PLANNING COMMISSION STAFF REPORT

FOR CONSIDERATION BY PLANNING COMMISSION ON OCTOBER 27, 2026

BEECHWOOD PLACE – DESIGN PLAN

REQUEST: Requesting approval from the Clermont County Planning Commission for Beechwood Place – Design Plan

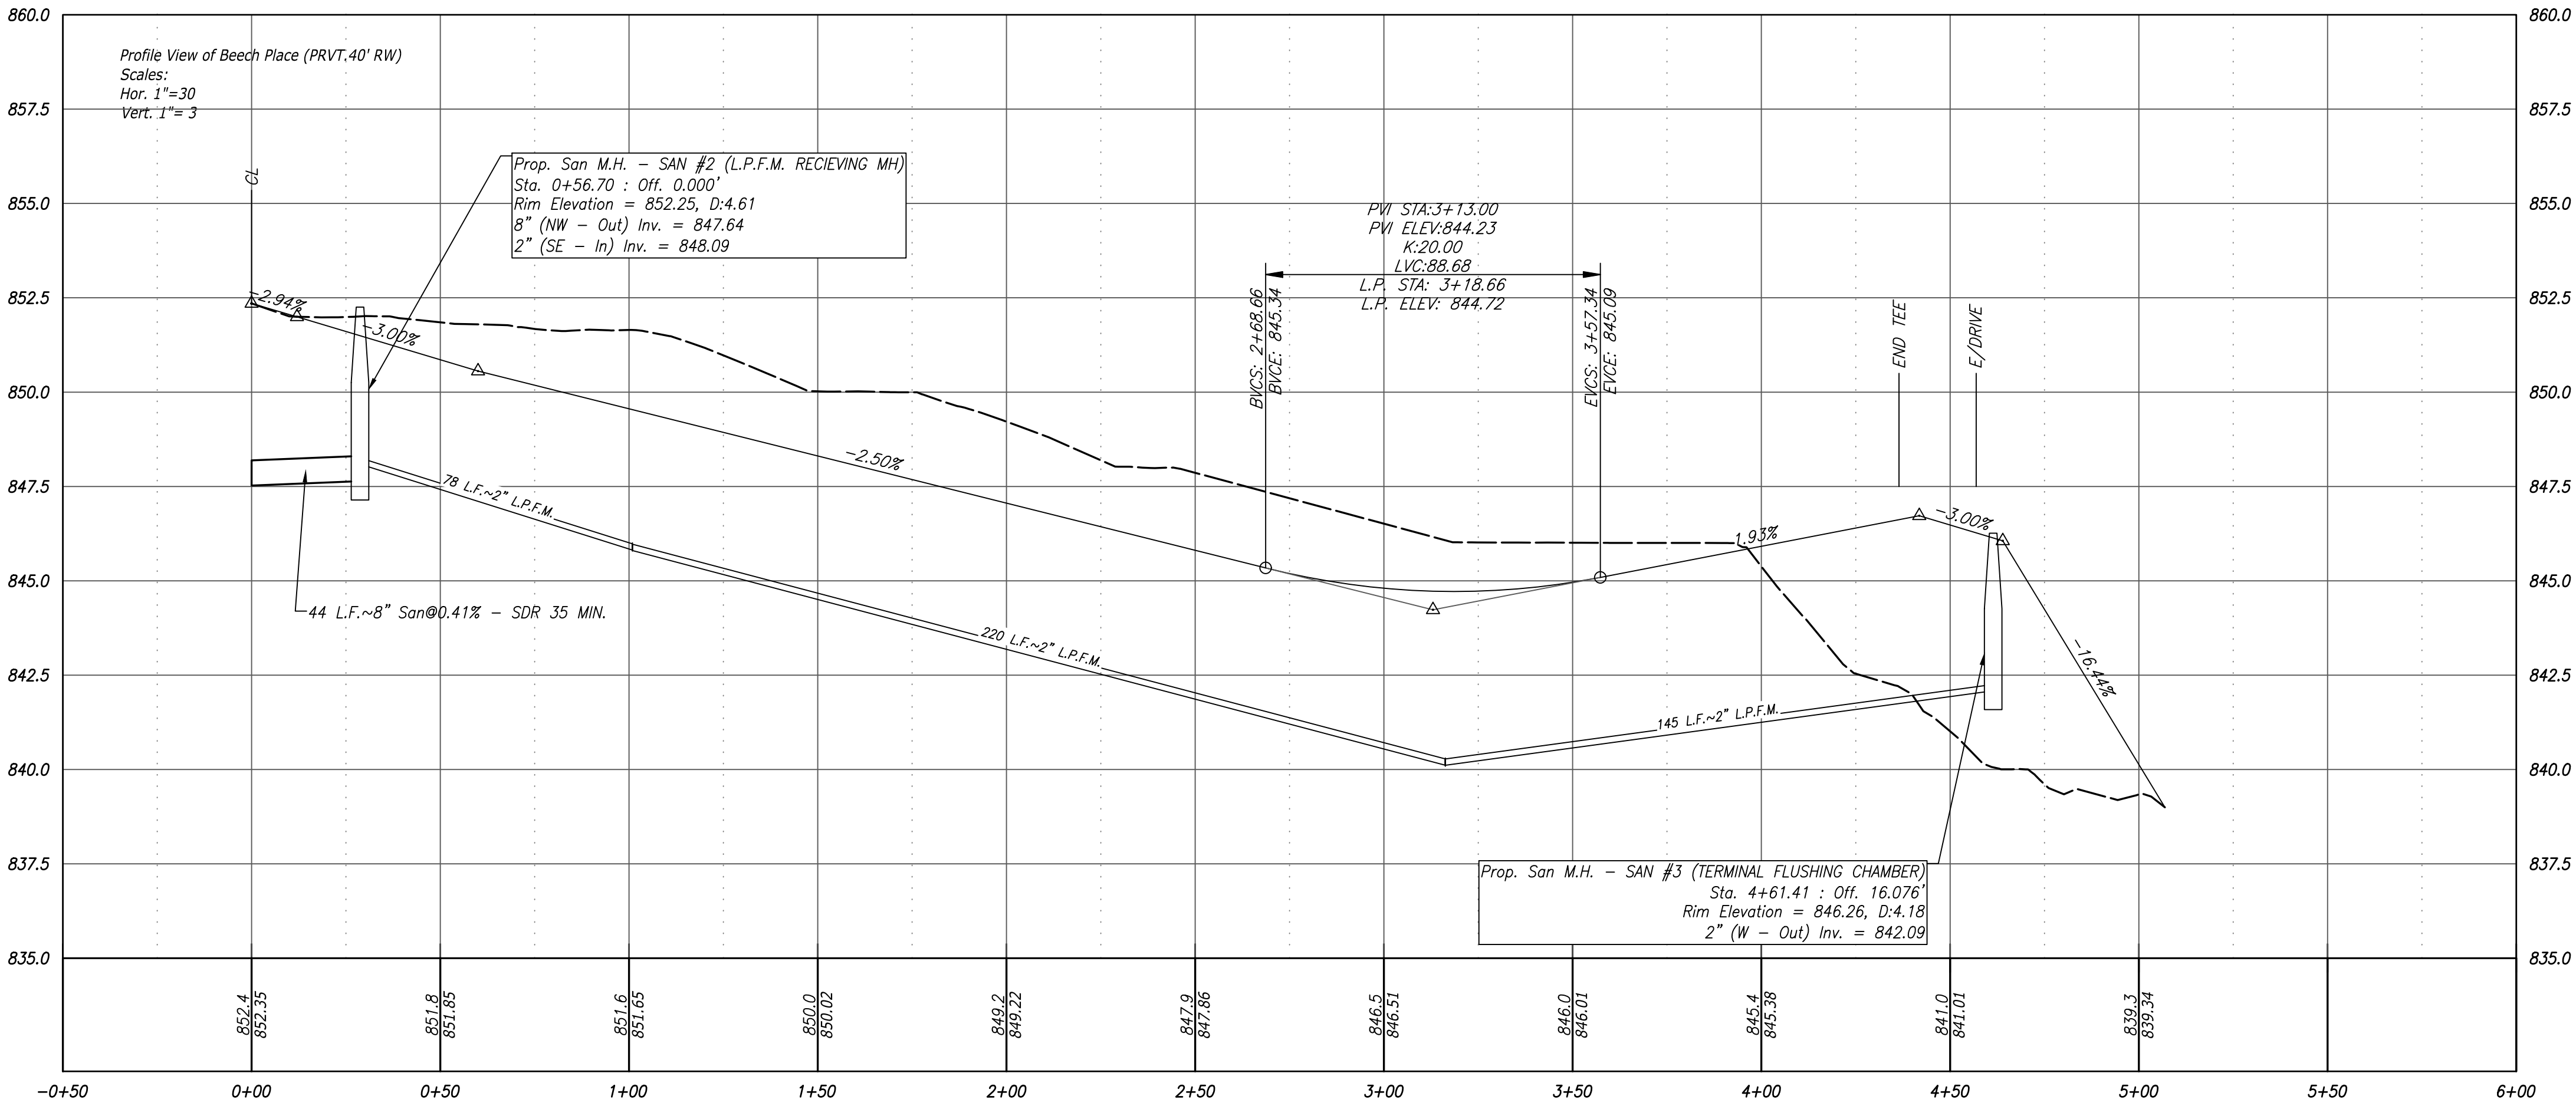
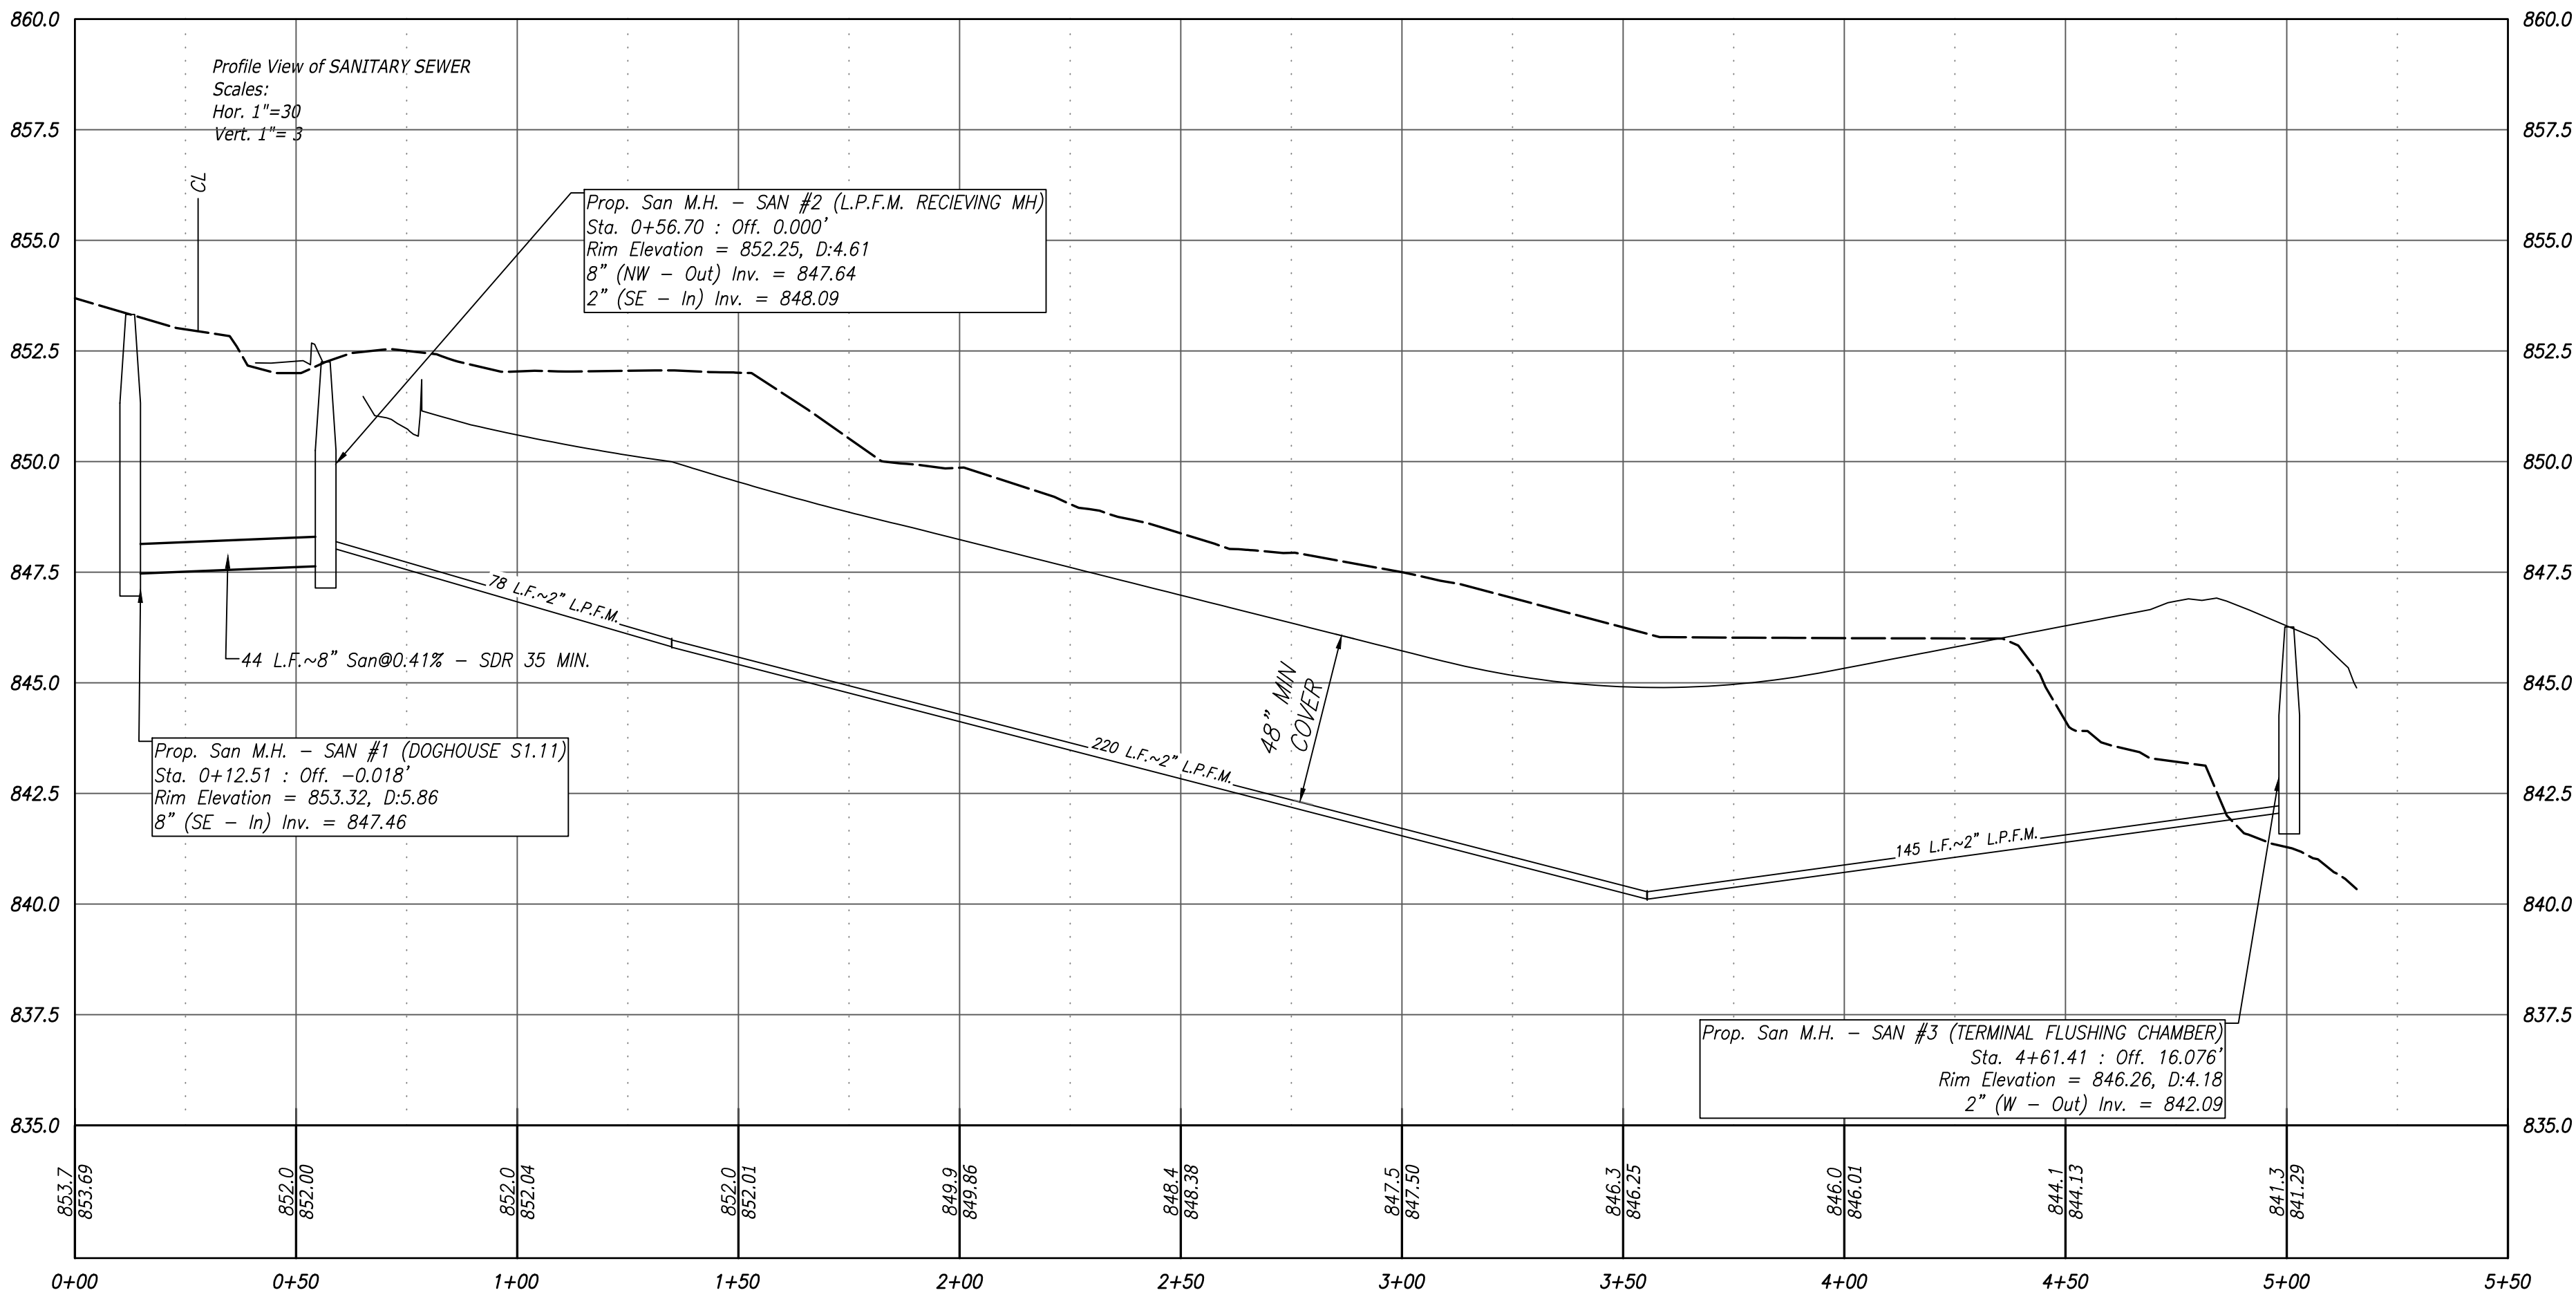
1. Provide calculations to verify sizing of 2-inch LPFM.
2. Provide a minimum of 4 feet of cover over sanitary sewers.
3. Manhole #2 needs to be lined per our standards.
4. Label the easement for Private Street that the sanitary sewer and water main is in as a "Public Utility Easement".
5. Water Main, Fire Hydrant, and Sanitary Sewer LPFM need to be within the appropriate easements per CCWRD standards. These can be found at wrd.clermontcountyohio.gov.
6. LPFM needs to have detail drawings S6.4, S6.5, and S6.6. This includes the low point manhole for draining the LPFM which is missing from profile sheets.

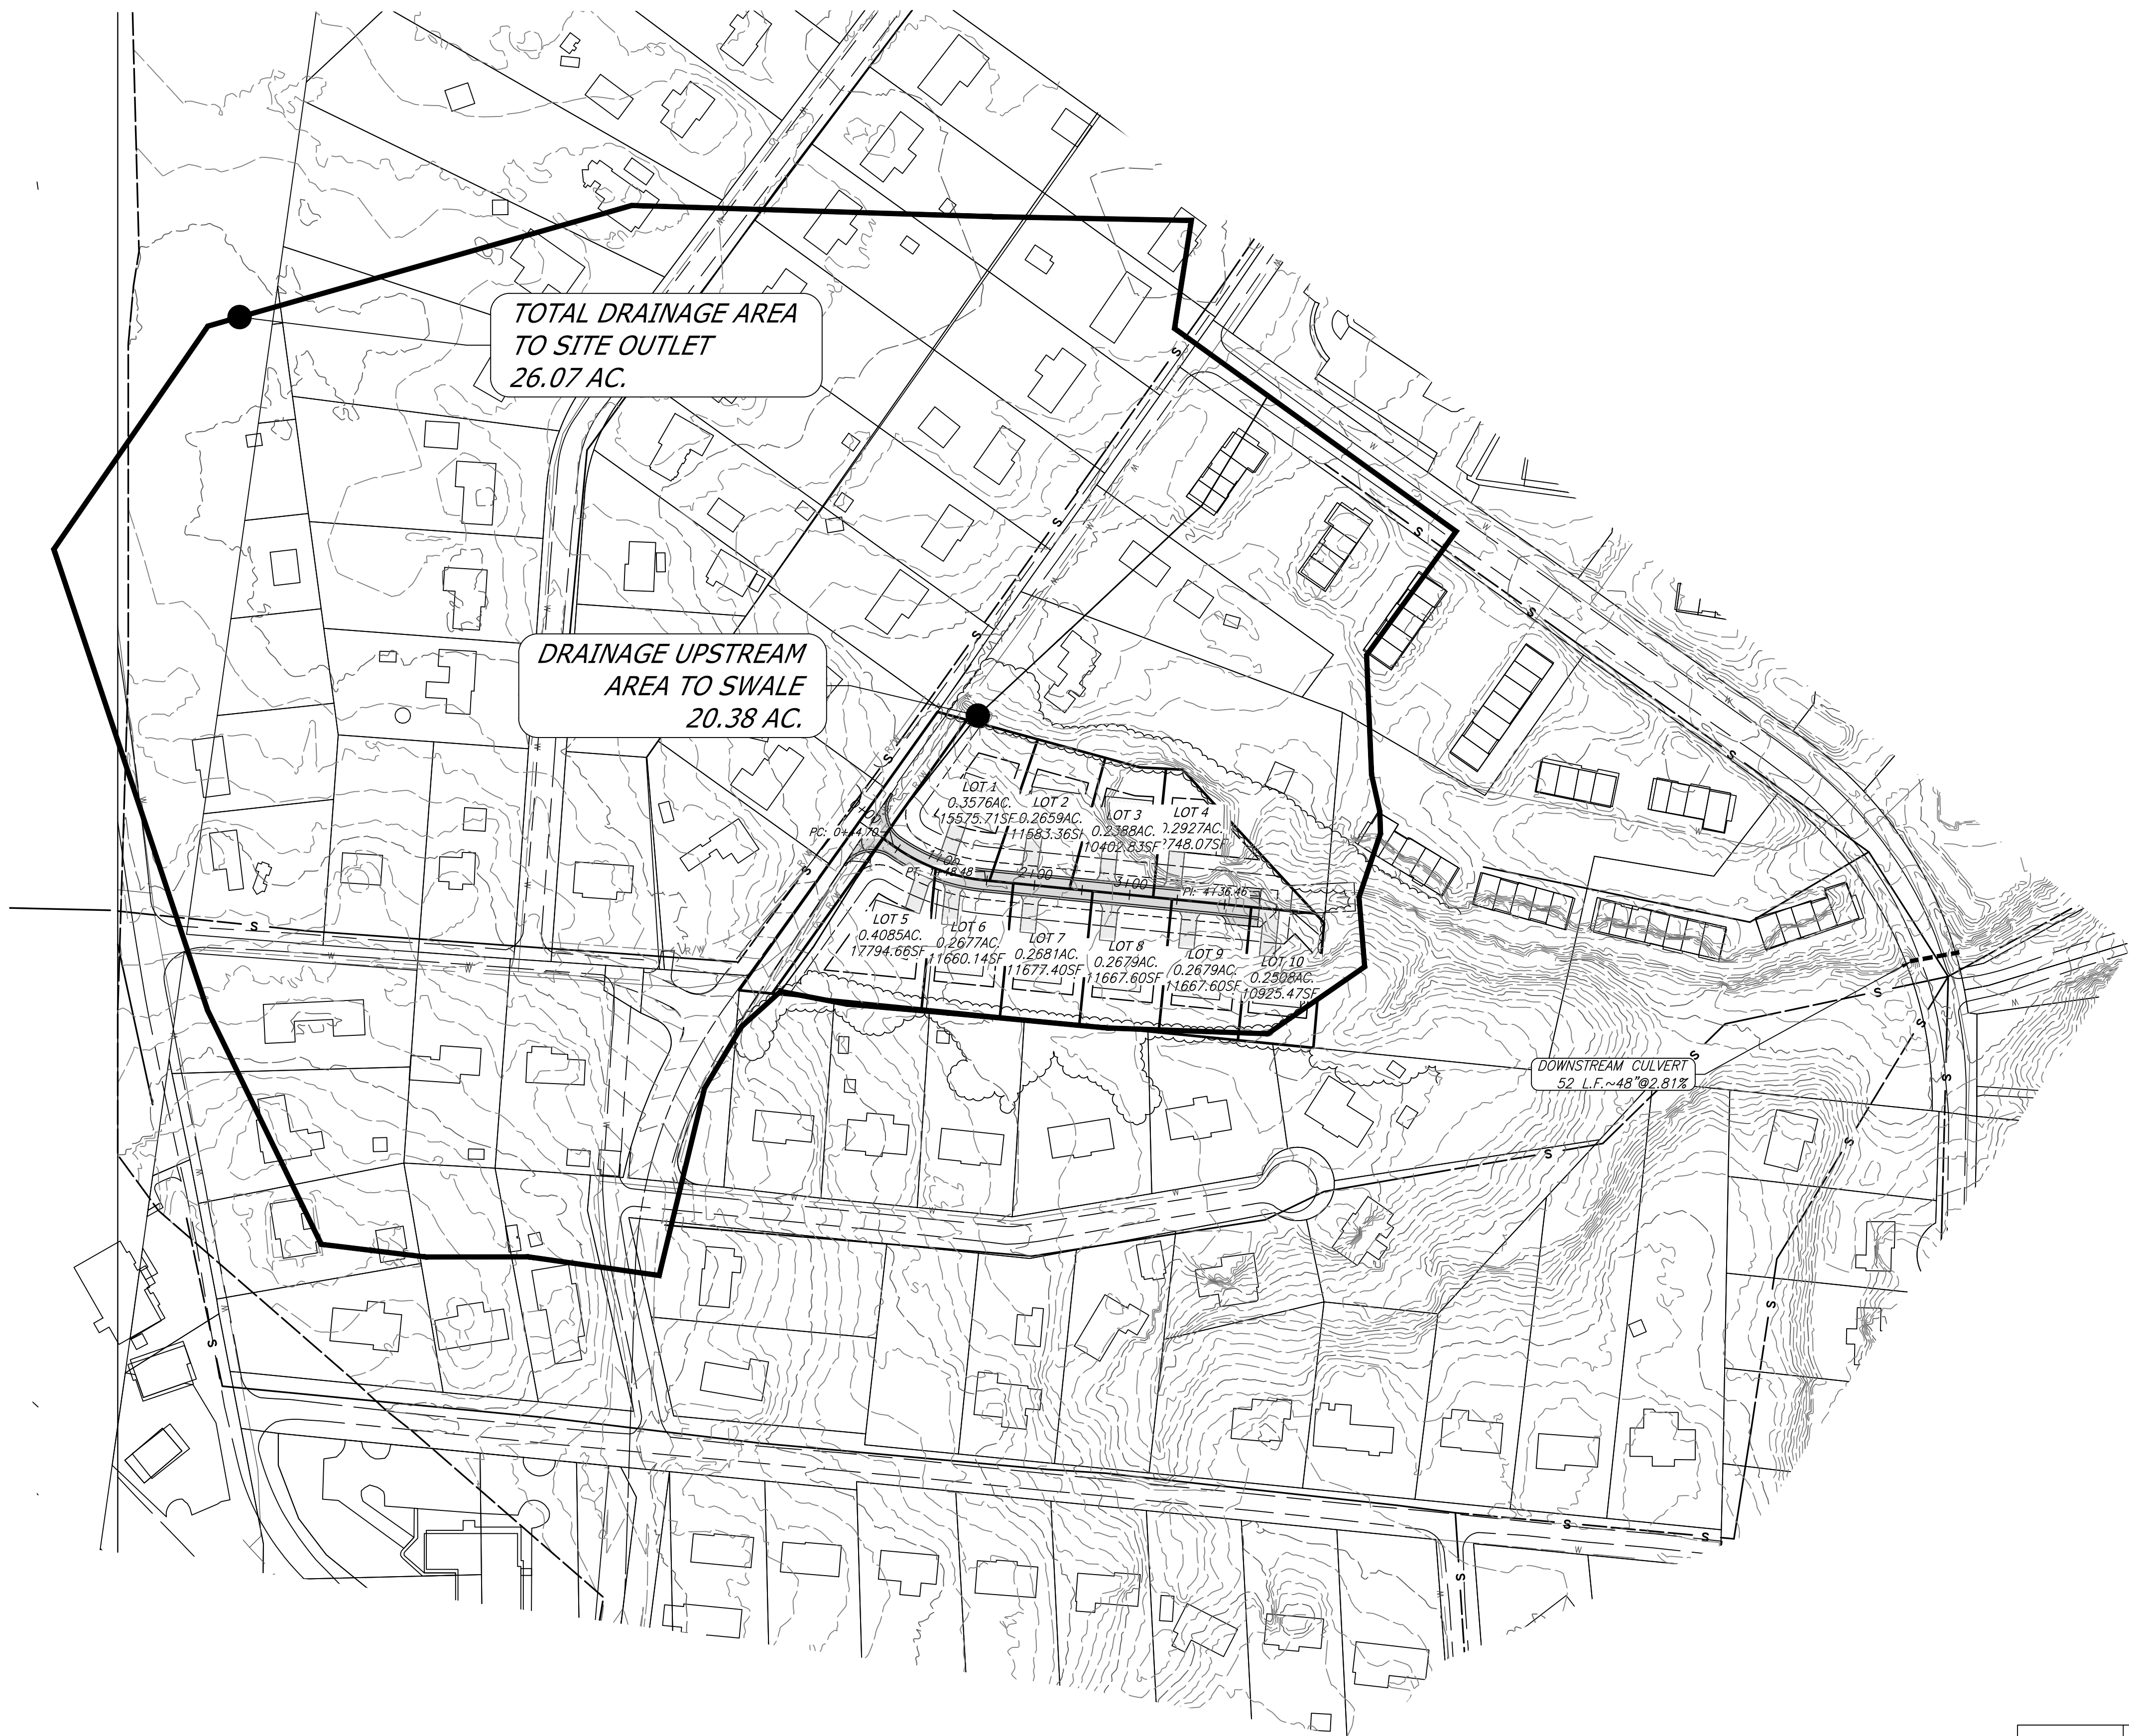
1. WMSC Section 410.1-1(G)(4)(a) – Detention Basin Location: Show the proposed detention or retention basin on the concept plan, including its approximate footprint, grading limits, and associated easements. The current plans reference stormwater detention but do not show the facility on the site plan or drainage area plan.

3. WMSC Sections 310.2 and 310.2-3 – Detention Requirements and Downstream Capacity: The note on Sheet 7 stating that the downstream 48-inch culvert under Aston Road can accommodate increased runoff does not, by itself, exempt the development from applicable detention requirements. Provide the required preliminary detention analysis and delineate the routing of the 20.38-acre upstream off-site watershed entering the on-site swale. Provide the applicable downstream capacity evaluation to demonstrate that the proposed drainage approach will not cause adverse flooding, erosion, or impacts to adjoining properties.
